UNITED STATES PATENT AND TRADEMARK OFFICE

APPLICATION NO.	FILING DATE	FIRST NAMED INVENTOR	ATTORNEY DOCKET NO.	CONFIRMATION NO.	
10/735,170	12/12/2003	Shunji Suzuki	JP920000179US2 1676 (8728-543D		
7590 06/29/2004			EXAM	EXAMINER	
Frank Chau, Esq. F. CHAU & ASSOCIATES, LLP 1900 Hempstead Turnpike East Meadow, NY 11554			RUDE, TIMOTHY L		
			ART UNIT	PAPER NUMBER	
			2871		
			DATE MAILED: 06/29/2004

Application N .	Applicant(s)				
	10/735,170	SUZUKI, SHUNJI				
Office Action Summary	Examin r	Art Unit				
	Timothy L Rude	2871				
The MAILING DATE of this communication appears on the cover sheet with the correspondence address						
Period for Reply	/ 10 OFT TO EVOIDE 0 MONTH!	C) FDOM				
A SHORTENED STATUTORY PERIOD FOR REPLY THE MAILING DATE OF THIS COMMUNICATION. - Extensions of time may be available under the provisions of 37 CFR 1.13 after SIX (6) MONTHS from the mailing date of this communication. - If the period for reply specified above is less than thirty (30) days, a reply - If NO period for reply is specified above, the maximum statutory period w - Failure to reply within the set or extended period for reply will, by statute, Any reply received by the Office later than

Figure 2 of Instant Application:

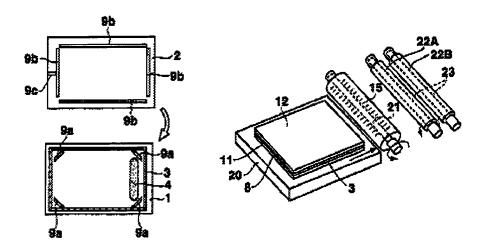
a second step of discharging bubbles mixed in the liquid crystal from the inside of the liquid crystal cell by pressing the liquid crystal cell in a direction where the two substrates approach to each other [Abstract and Figure 9C; please consider the similarity of the illustrations of Kawasumi relative Applicant's Figure 2].

Figures from Kawasumi:

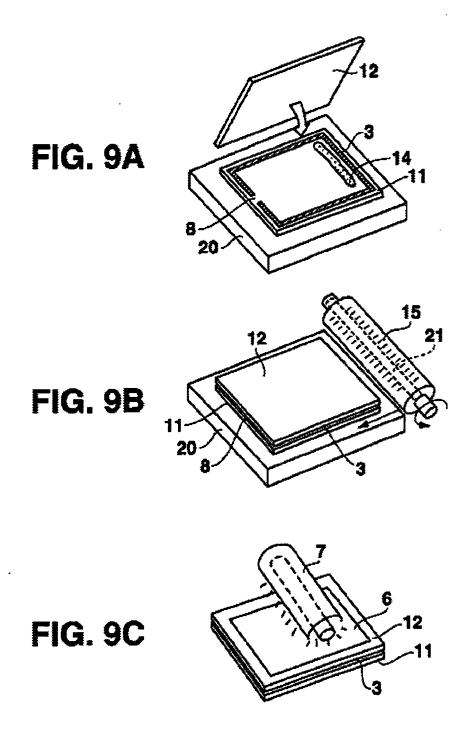
As to claim 10, Kawasumi discloses [entire patent, especially embodiment 6, Figures 9A-9C, col. 9, line 23 through col. 10, line 62] a method of fabricating a liquid crystal cell, comprising:

a first step of obtaining a liquid crystal cell having liquid crystal [14] filled between two substrates stuck together by a sealant [Figures 9A and 9B];

As to claim 11, Kawasumi discloses the method of fabricating a liquid crystal cell according to claim 10, wherein in the first step, the liquid crystal cell is obtained by dropping the liquid crystal [14, Figure 9A], onto one of the substrates coated with the sealant [3], and then superposing the other substrate thereon [Figures 9A and 9B].
